Stantec Consulting Services, Inc.
5 Burlington Woods Drive
Burlington, MA 01803

April 21, 2020

Subject: Traffic Consulting Peer Review - Proposed Village at Cricket Lane
Chapter 40B Development, Newbury, Massachusetts

Sight Line Findings (1 of 2)

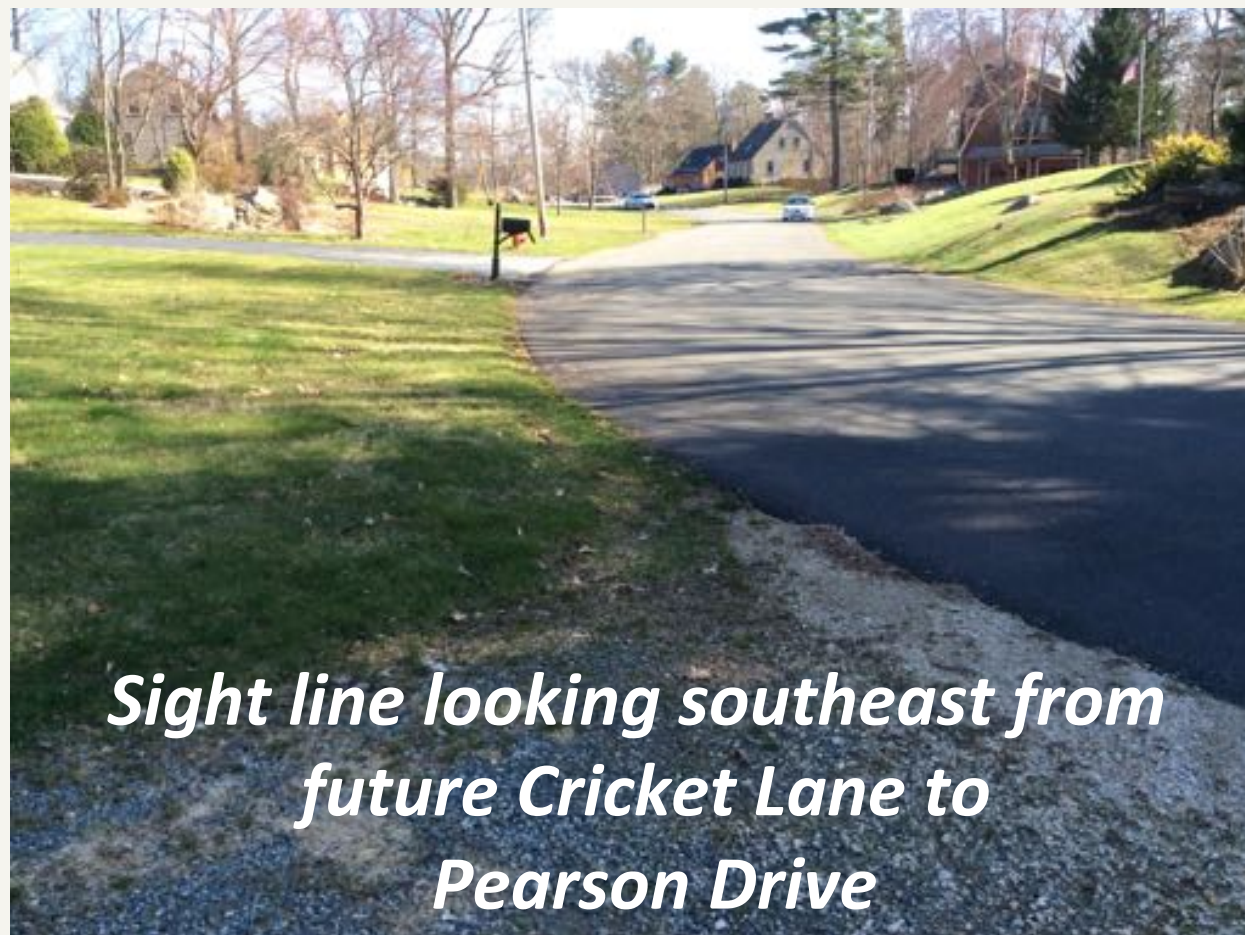
- ⦿ Sight line measurements – 490' to the southeast and 265' to the southwest --at the proposed Cricket Lane with Pearson Drive intersection. These measurements, as presented in the TA are reasonable and adequate for conditions based on observations.

Summary of Long Dead End Issue

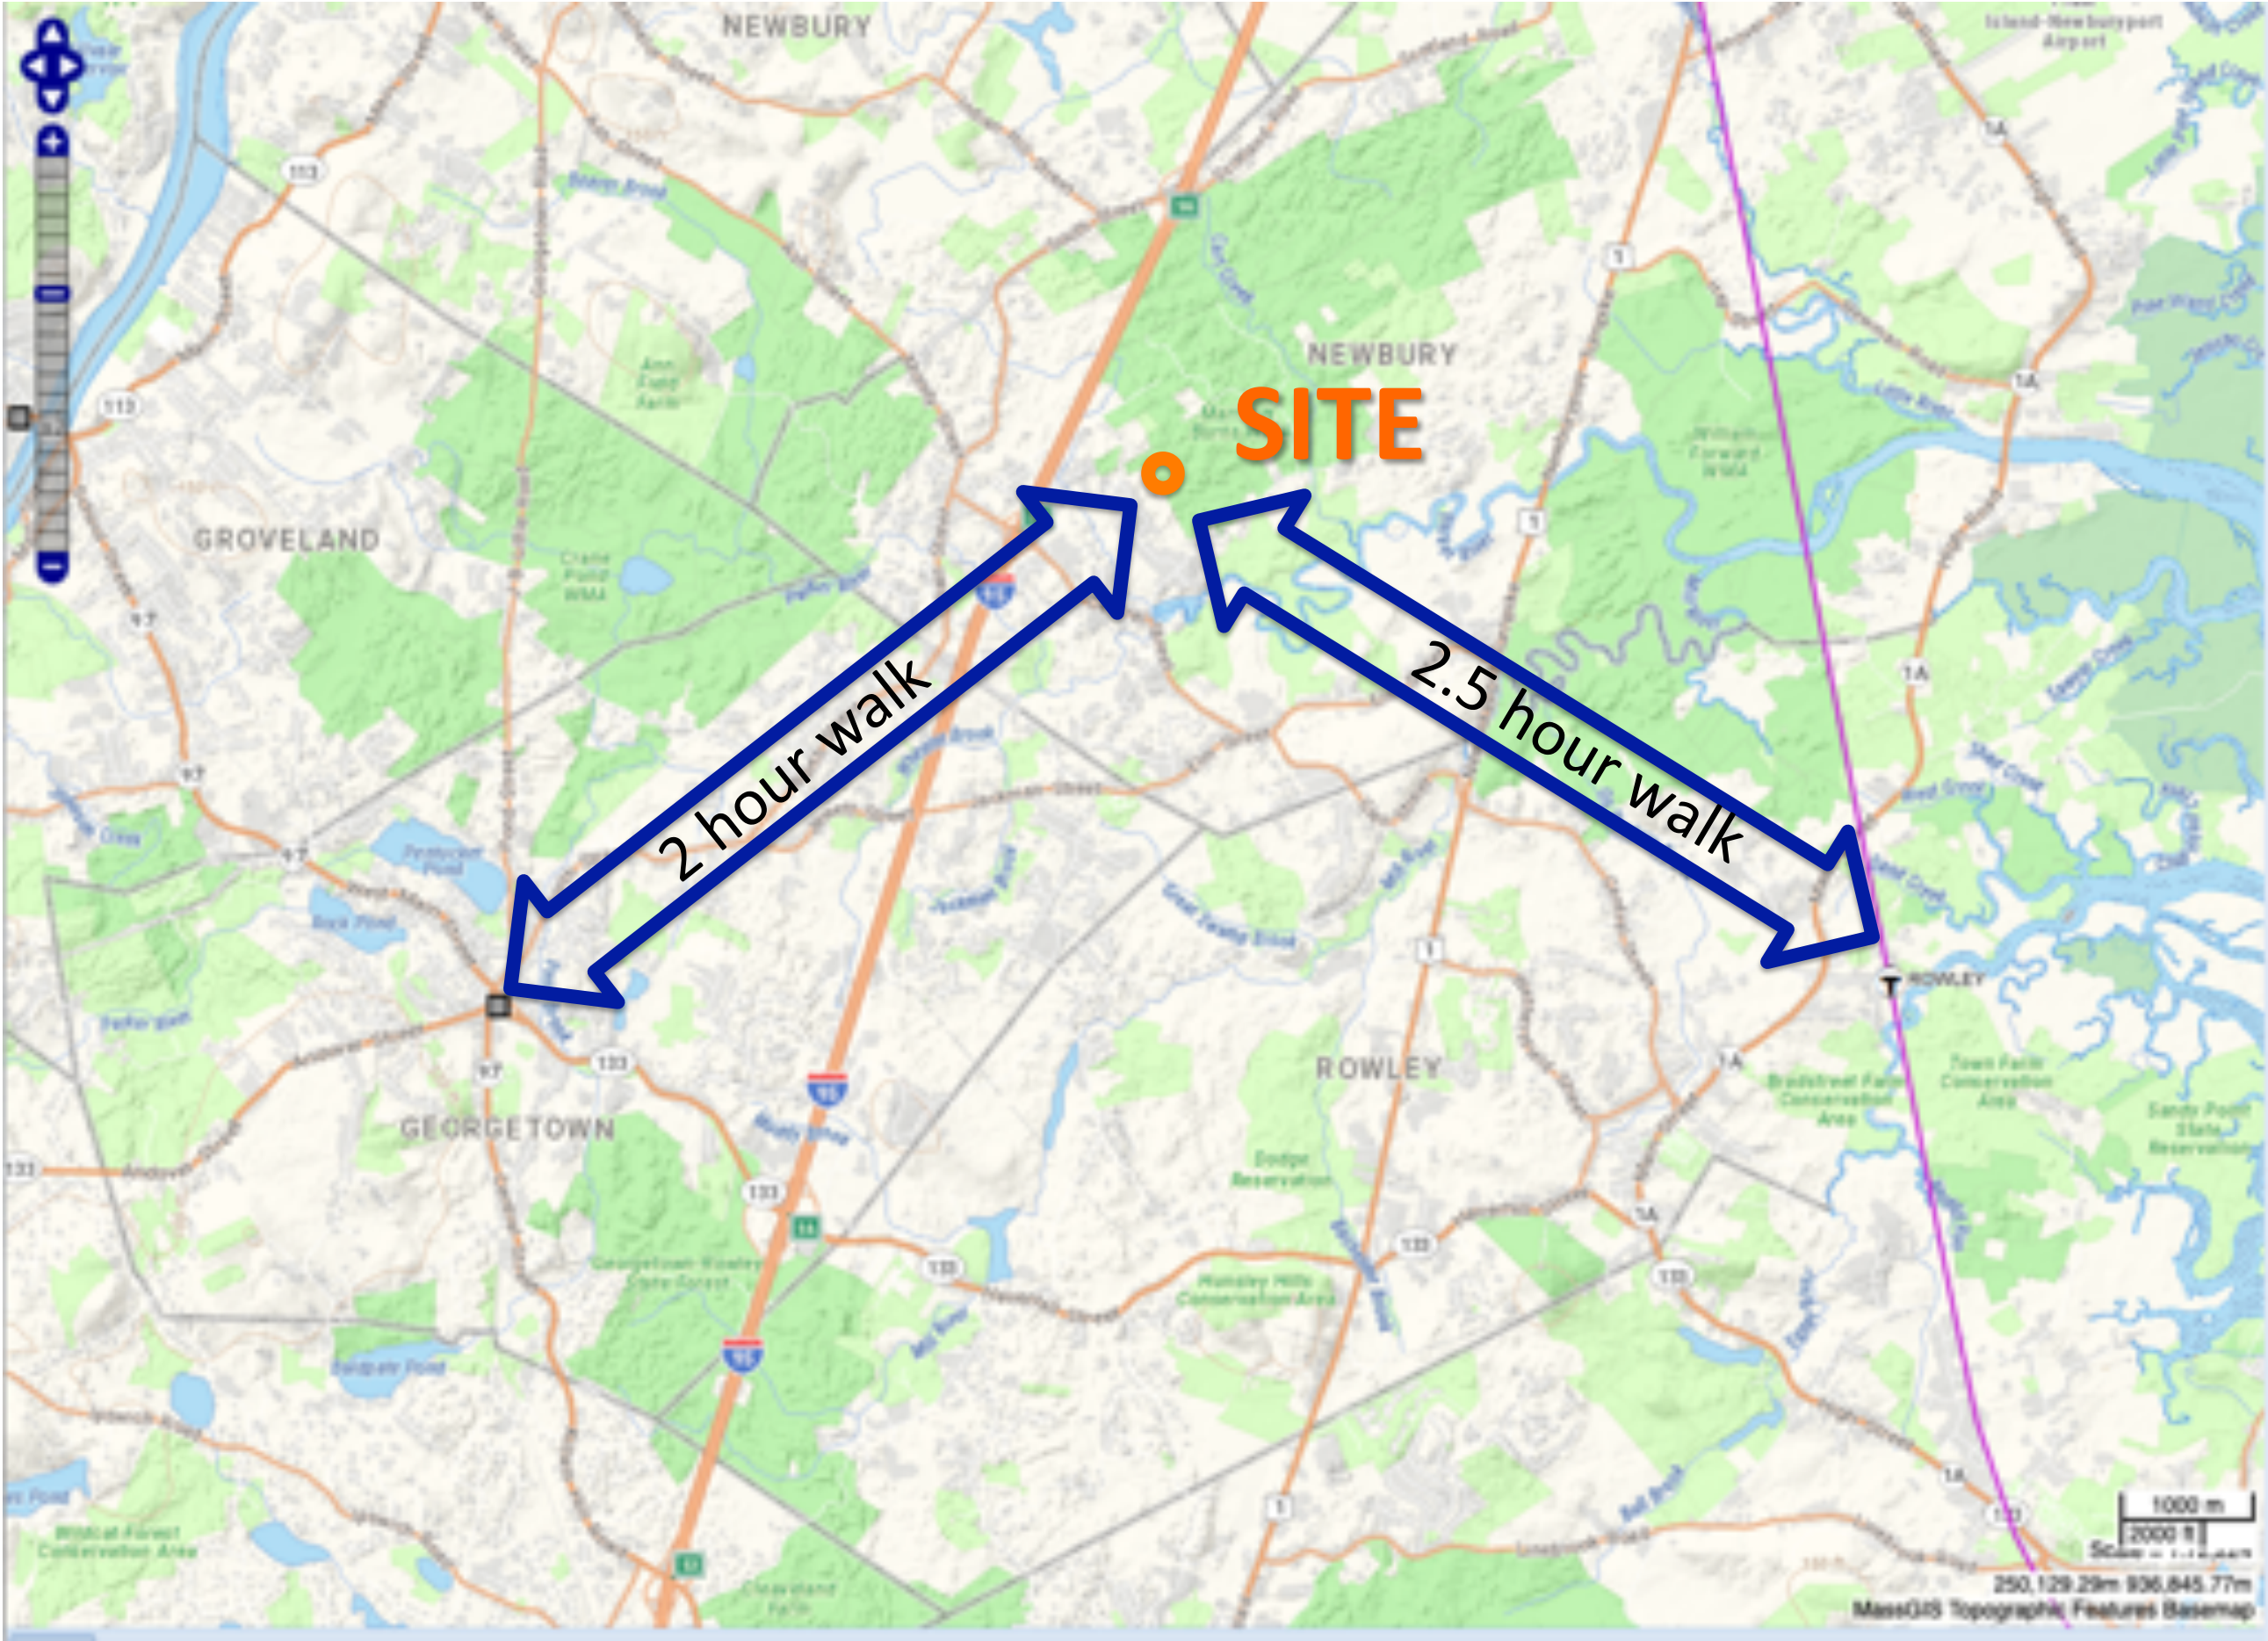
Conclusion:
Proposed single access route much longer than cul-de-sac systems recommended in vast majority of Massachusetts communities, but minimum NFPA requirements are met.
